SR 0083 Section 094 Interstate 83 South Bridge Replacement Project Dauphin County

FINDING OF NO SIGNIFICANT IMPACT

I-83 South Bridge Replacement Project

ATTACHMENT A
ENVIRONMENTAL ASSESSMENT RESPONSE TO
COMMENTS REPORT

I-83 SOUTH BRIDGE EA
PENNSYLVANIA BIKE ROUTE J

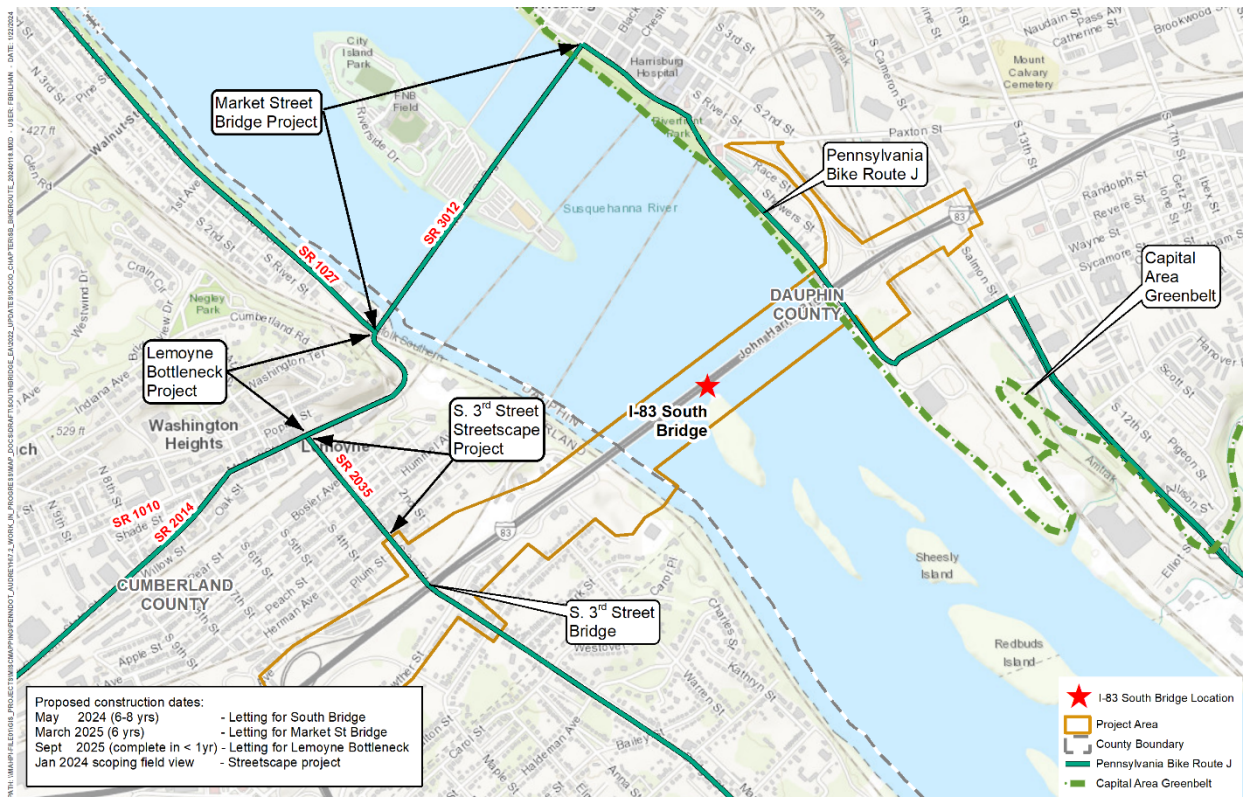
In the Harrisburg area, designated Bike Route J uses the S. 3rd Street Bridge (SR 3025) in Lemoyne, turns right on Market Street (SR 1010), goes through the area known as the “Lemoyne bottleneck,” crosses the Market Street Bridge (SR 3012) over the Susquehanna River, and ties into the Capital Area Greenbelt Trail on the east shore of the river. The I-83 South Bridge project includes the replacement of the S. 3rd Street Bridge in Lemoyne, which will be widened from three lanes with narrow shoulders and a single sidewalk to four lanes with 5-foot shoulders and 5-foot sidewalks on both sides. The existing Market Street Bridge includes bicycle/pedestrian facilities. The Market Street Bridge is currently under study for rehabilitation and would include a bike/ped facility either on the existing bridge or on a separate structure immediately downstream of the existing bridge that is being considered for use as a combined utility bridge and bike/ped facility. A separate project is planned for improving the Lemoyne bottleneck area including improved accommodations for bicycles and pedestrians. Lemoyne Borough is also advancing a streetscape project on S. 3rd Street to improve sidewalks, crosswalks, and streetlights between Herman Avenue and Market Street. See Figure below, which shows Bike Route J and programmed improvement projects along Bike Route J.

The I-83 East Shore Section 3 (ESS3) project from Cameron Street to the Eisenhower interchange includes traffic signal upgrades, new Americans with Disabilities Act (ADA)-accessible ramps and sidewalks, and bike lanes/shoulders to improve safety for non-motorized travelers and improve community connectivity throughout the project corridor. Paxton Street, Cameron Street, 13th Street, 17th Street, 19th Street, and 29th Street will be reconstructed to accommodate sidewalks (ADA standards) or multi-use paths along with pedestrian scale lighting. In addition, shoulders/bike lanes/multi-use paths will be constructed to separate bicycles from the vehicular lanes.

The Market Street Bridge West and East projects, as well as the Lemoyne Bottleneck improvements, are identified in the 2023-2026 Harrisburg Area Transportation Study (HATS) Transportation Improvement Program (TIP) as providing focused improvements for pedestrians and cyclists within the Harrisburg area ([HATS Transportation Improvement Program \(tcrpc-pa.org\)](https://www.tcrpc-pa.org/)). Market Street Bridge construction is planned to begin in March 2025 and take approximately six years to complete, while the Lemoyne Bottleneck project is planned to begin in September 2025 and will be completed in approximately one year. The I-83 ESS3 project is currently under construction.

SKETCH OF ADDITIONAL RAMP X CONCEPT

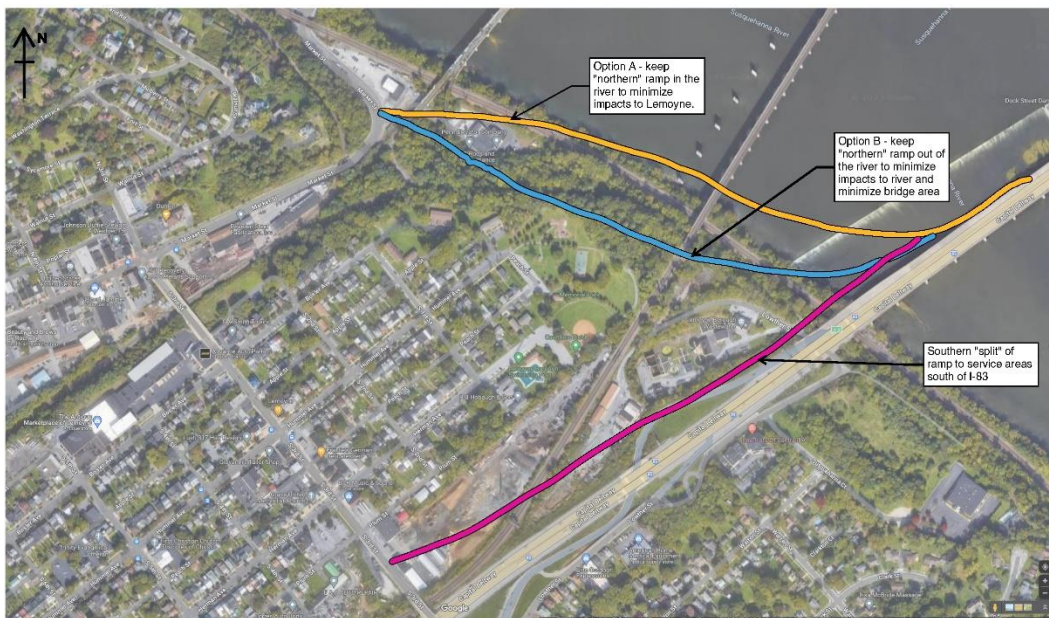
Concept presented verbally during public hearing. This is the project team's interpretation of the presented description.

I-83 Ramp X additional concept – An additional concept for the I-83 southbound off-ramp of the Lemoyne exit was proposed at the public hearing. This option would include one southbound exit ramp that would split into two ramps – one for those destined for the north side of Lemoyne and one for those destined for areas south of I-83. A sketch plan of what the project team feels the commentor was describing is included as I-83 Ramp X Concept 5. It is doubtful this concept would be geometrically feasible with the vertical clearances needed above the Susquehanna River for hydraulic reasons and above/below the existing railroad bridges and other rail lines. Even if a design could be developed, this ramp system would have numerous environmental impacts, utility impacts, and much higher initial construction and long-term maintenance costs. The “northern” ramp would also tie into the Lemoyne Bottleneck, exacerbating the traffic congestion in this area. Due to these reasons, this new concept is not recommended for additional study.
